Access Compliance Report

Public Rights-of-Way

(Curb Ramps)

Intersection ID: 44481	Main Street: CHALKSTONE_RD	Cross Street: REDDING_GLEN_AV	Location: SE
ADA ID: 2DD1F2799344	Ramp Type: BlendTrans1	Initial Pass/Fail: Fail	Overall Compliance: No
Severity Score: 12.5			
Codes/Mitigation Info/Possible Solution		Field Measurements/Component Compliance

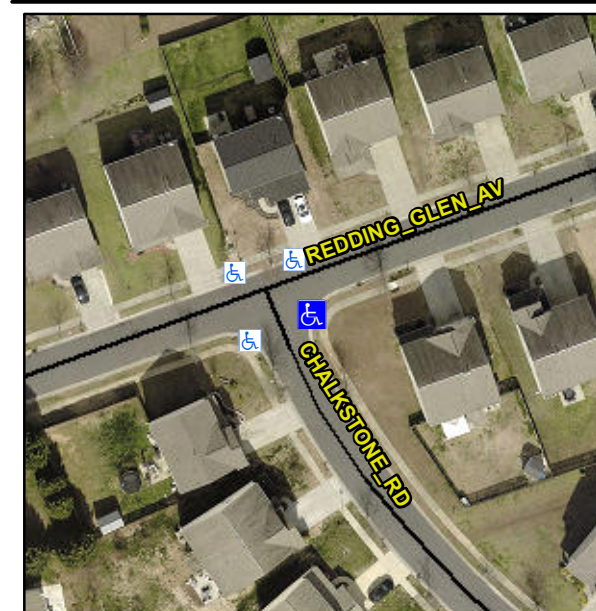
Not Found, R304.5.3

Compliance	Description	Data	Compliance	Description	Data
N/A	Ramp Length (in)	46.0	Yes	BlendTrans Slope (%)	3.6
Yes	Ramp Width (in)	48.0	No	BlendTrans XSlope (%)	6.9
N/A	Flare Type LT	N/A	N/A	Flare Type RT	N/A
N/A	Flare Slope LT (%)	N/A	N/A	Flare Slope RT (%)	N/A
N/A	Flare Traversable LT?	N/A	N/A	Flare Traversable RT?	N/A
N/A	Landing Length (in)	N/A	N/A	DWS Provided?	N/A
N/A	Landing Width (in)	N/A	N/A	DWS Contrast?	N/A
N/A	Landing Slope (%)	N/A	N/A	DWS Length (in)	N/A
N/A	Landing X Slope (%)	N/A	N/A	DWS Full Width?	N/A
N/A	Landing Curb? (Y/N)	N/A	N/A	DWS Offset (in)	N/A
N/A	Shared Landing?	N/A			
N/A	Gutter Ponding?	N/A	N/A	Gutter Slope (%)	N/A
N/A	Gutter Lip Ht (in)	N/A	N/A	Gutter X Slope (%)	N/A
N/A	Painted X Walk1?	No	N/A	Painted X Walk2?	No
	X Walk 1 Direction	To N		X Walk 2 Direction	To W
	X Walk 1 Width (in)	N/A		X Walk 2 Width (in)	N/A
	X Walk 1 Slope (%)	3.1		X Walk 2 Slope (%)	0.5
	X Walk 1 X Slope (%)	2.8		X Walk 2 X Slope (%)	1.9

N/A	Ramp inside XWalk1?	N/A	N/A	Ramp inside XWalk2?	N/A
	Road Slope (%)	2.8		Clear Space?	N/A
	Road X Slope (%)	1.2	N/A	Clear Space to XWalk (in)	N/A
N/A	Any Obstructions?	N/A	N/A	Storm Grate/Utility Hazard?	N/A
	Obstruction Type			Storm Grate/Utility Type	
		N/A			N/A
			Yes	Surface Condition? (G/P)	Good
			No	Curb Slope (%)	22.2

Remove & Replace Curb Ramp With Two New Directional Ramps or Equivalent.
